Docket Item #9
SUBDIVISION #2006-0001

Planning Commission Meeting
May 4, 2006

ISSUE: Consideration of a request to resubdivide the subject properties.

LOCATION: 5300 & 5310 Seminary Road

TREES

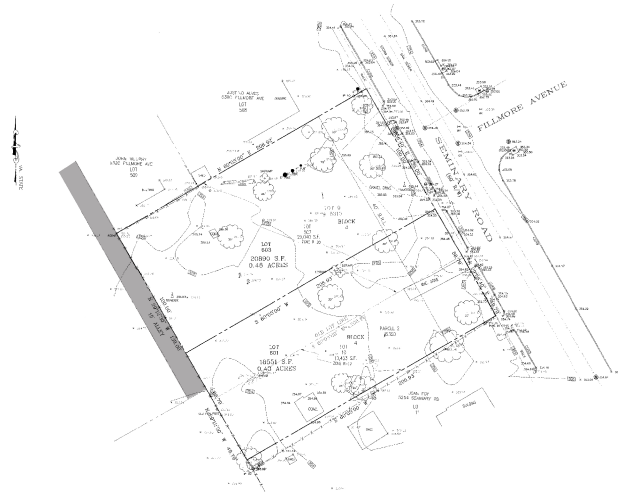
Staff is concerned generally with the loss of trees. The subject lots contain large trees such as Willow, White Oak, and Oak, measuring 30 inches and greater in circumference, which add to the character of the neighborhood. Staff has included a condition requiring the applicant to submit and comply with a tree preservation plan that indicates tree protection zones which shall be to the approval of the City Arborist and the Director of Planning and Zoning. Tree preservation is important because it is consistent with the character of the community.

ALTERNATIVE #2- SHARED CURB CUT ACCESS

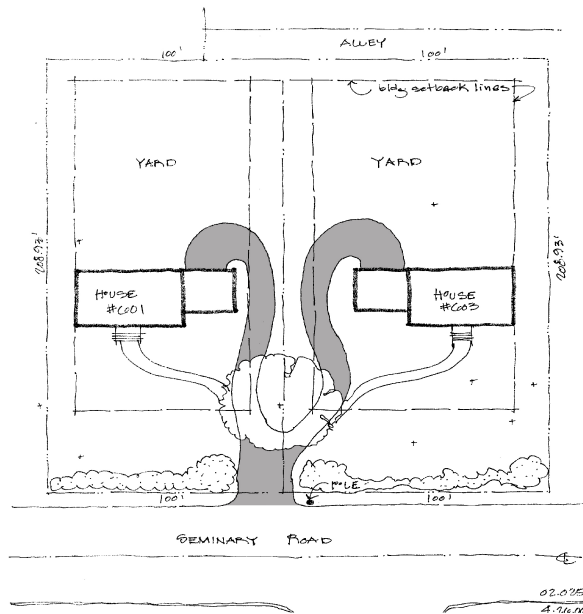
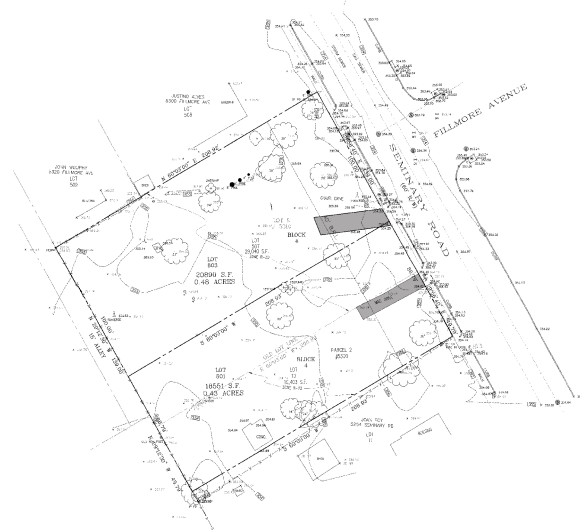
Another possible solution is for the properties to have a single shared curb cut along Seminary Road. This option would eliminate two of the three existing curb cuts along Seminary Road, providing a single, shared access point for both properties. The driveways could also be configured to minimize impacts on existing mature trees. However, the applicant is concerned about future maintenance issues that may arise between two different future owners.

In addition, in order to avoid several large trees on the property, the only viable design is a 22 foot driveway entrance that splits into two driveways around a prominent tree. Even with this design, the mature tree would be highly threatened.

The applicant is also concerned about the significant additional cost associated with the curb cut widening and closure of two of the curb cuts. The applicant has indicated to staff that it is possible to build a new house on each existing lot, without this resubdivision and without removing any curb cuts.

On balance, staff finds that the single curb cut for each property is the better alternative in this situation. The alternative poses the least risk to large mature trees and is more consistent with the development pattern that exists along Seminary Road. One curb cut will still be removed and the applicant has agreed to this alternative.
